ADDENDUM NO. 2 TO PROJECT NO. 44496

**CONSTRUCTION WORK, HVAC WORK AND ELECTRICAL WORK
REPLACE UNDER GROUND HEAT AND WATER LINES
ULSTER CORRECTIONAL FACILITY
750 BERME ROAD
NAPANOCH, NY**

January 29, 2014

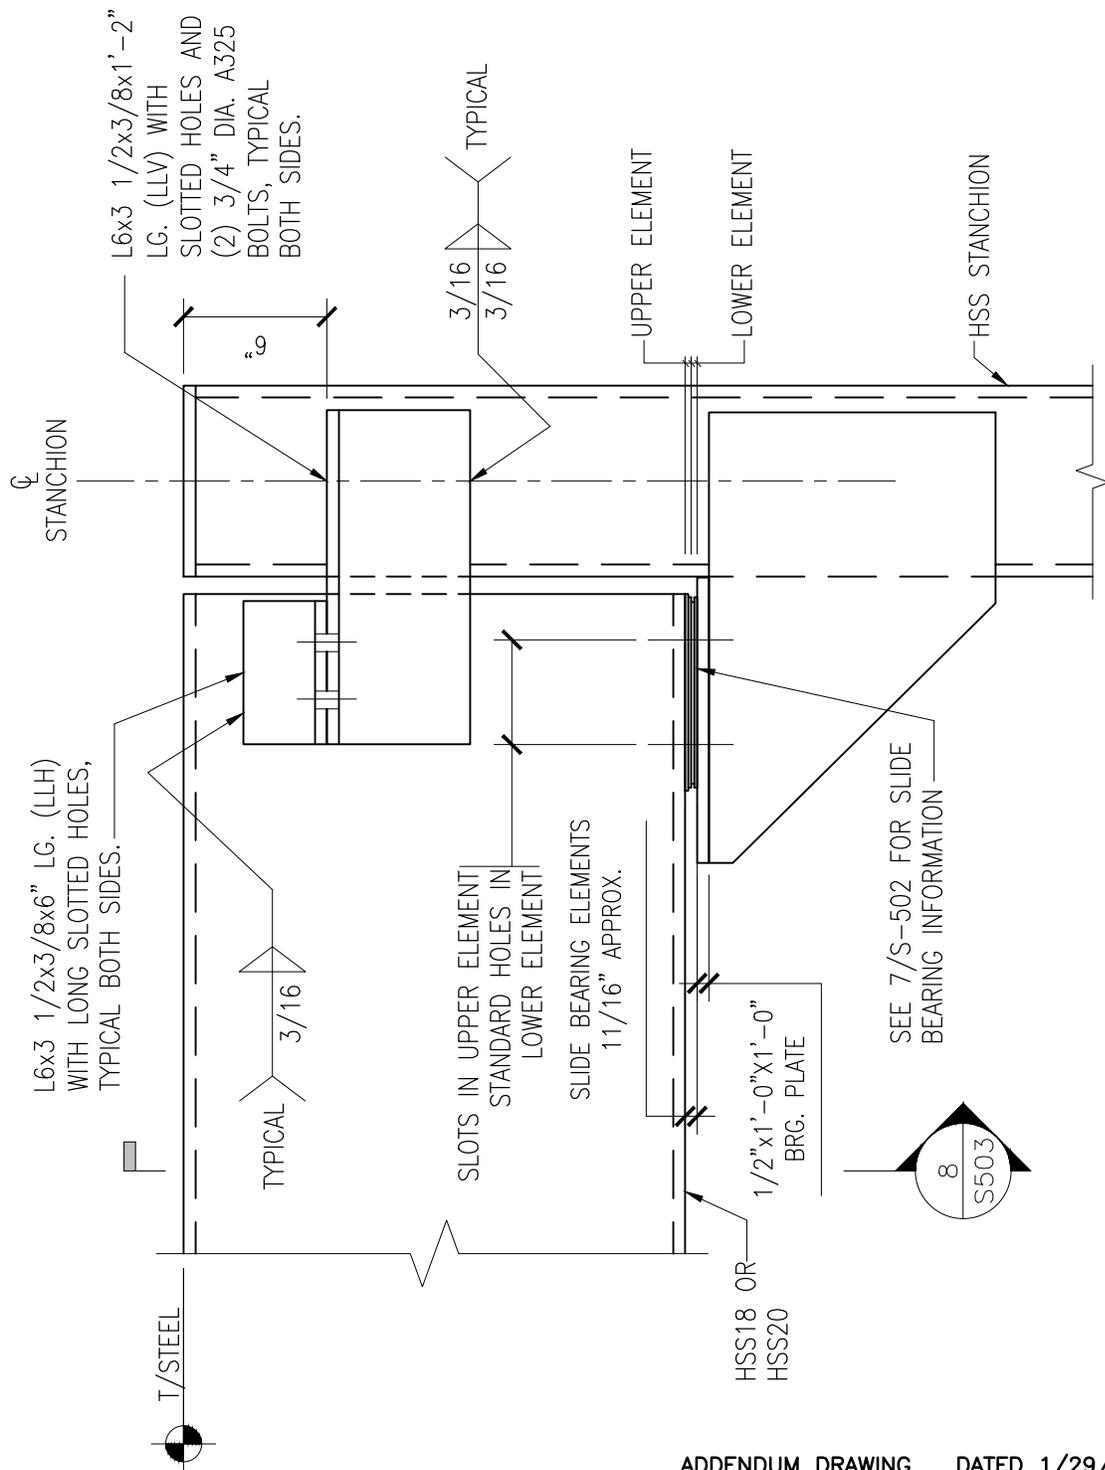
- d. DETAIL 11: Refer to Addendum Drawing No. S-510 dated 1/29/14 for Revised Detail.
25. Drawing No. S-503, DETAILS:
 - a. DETAIL 6: Delete this Detail in its entirety. Refer to Addendum Drawing No. S-511 dated 1/29/14 for Revised Detail.

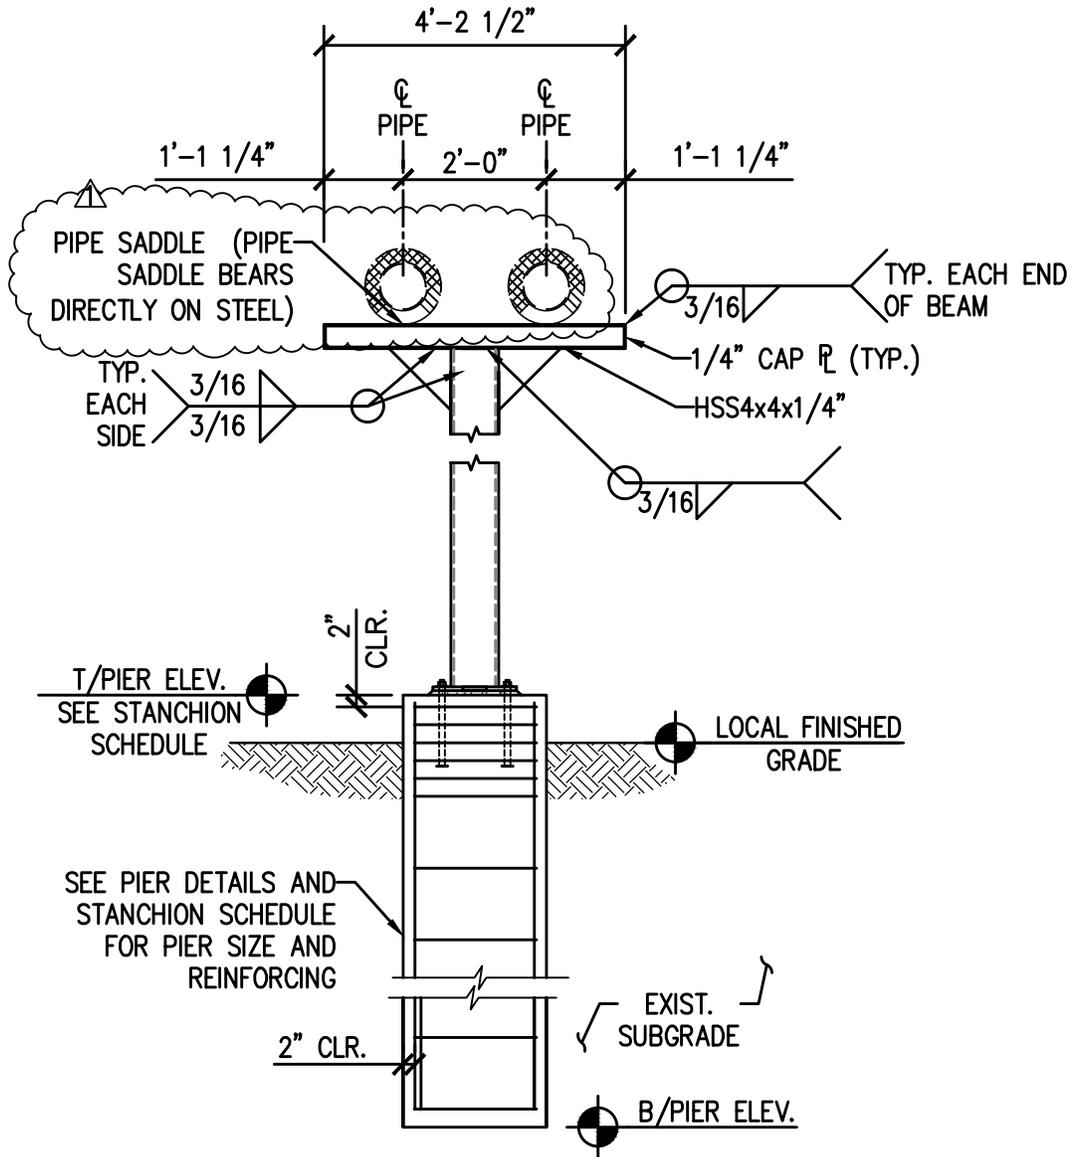
- b. DETAIL 7: Delete this Detail in its entirety. Refer to Addendum Drawing No. S-512 dated 1/29/14 for Revised Detail.
26. Drawing No. S-504, DETAIL 6: Delete in its entirety. Refer to Addendum Drawing No. S-513 dated 1/29/14 for revised Detail.
